Comment	51	Comment Status D		bucket	Dawe, Pie	ers		Nvidia		
Chan	ge 802.3-202x t	o 802.3-2022 and correct list of	amendments		Comment	Туре	т	Comment Status D		
Chan		is an amendment of IEEE Std 8						DM systems - not. Figure 156- WDM BLACK LINK"	1 has it right: "	PMD FOR DWDM
		Std 802.3cs-202x, IEEE Std 802 2x, IEEE Std 802.3cx-202x, and			Suggested	Remedy				
				.3CZ-2UZX.	Chang	ge "for ope	eration	over DWDM systems" to "for D	WDM operatio	on"
,	Response	Response Status <b>W</b> T IN PRINCIPLE.			Proposed	Response	Э	Response Status W		
FRUI		I IN FININGIFLE.			PROP	, OSED RE	EJECT	1		
chair		t order consistent with the order r descriptions as required. See			The na Force"		e task f	force is "IEEE P802.3cw 400 G	b/s over DWDI	M Systems Task

TYPE: TR/technical required ER/editorial required GR/general required T/technical E/editorial G/general	C/ FM	Page 1 of 122
COMMENT STATUS: D/dispatched A/accepted R/rejected RESPONSE STATUS: O/open W/written C/closed	U/unsatisfied Z/withdrawn SC FM	9/9/2022 3:06:09 PM
SORT ORDER: Clause, Subclause, page, line

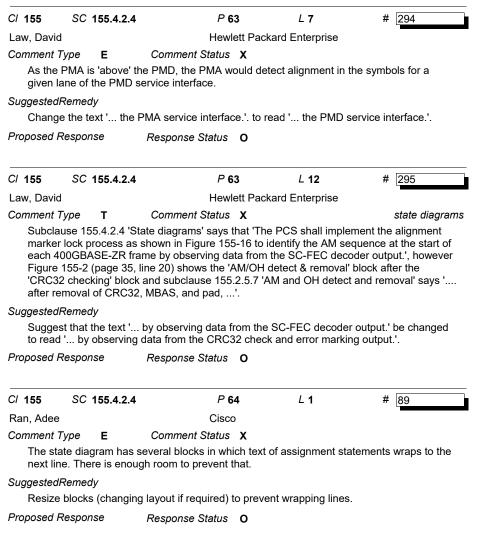
Text on FAW synchronization seems to imply that there is a FAW synchronization process for each lane, for a total of 4 independent FAW synchronization processes. Actually there are 2 FAW synchronization processes, one per polarization (see figure 115.10 and clause 155.3.3.7)

Replace: "The synchronization process operates independently on each lane" with: "The synchronization process operates independently on each polarization"

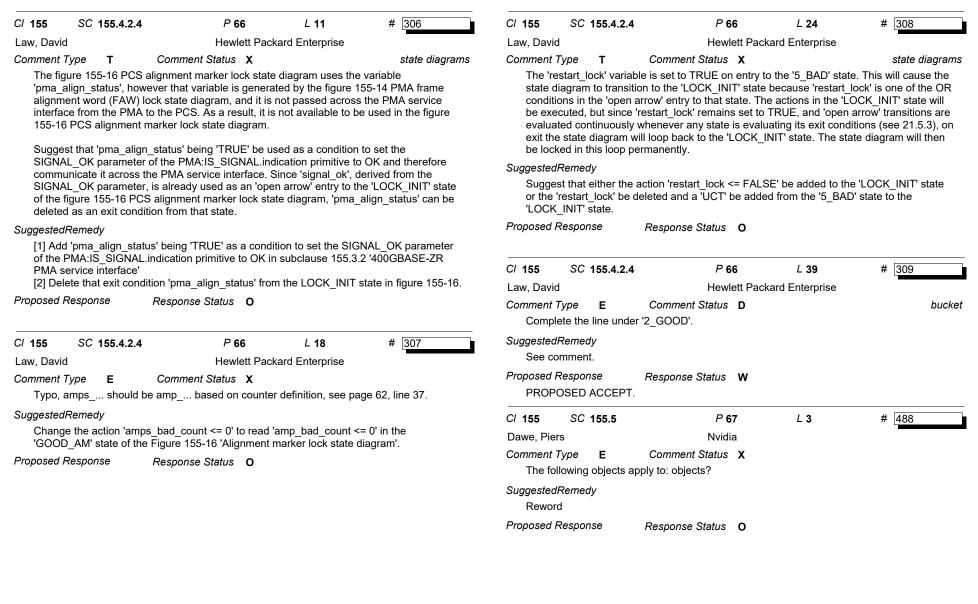
In the GET\_BLOCK state, the variable slip\_done should be faw\_slip\_done

Change slip\_done to faw\_slip\_done
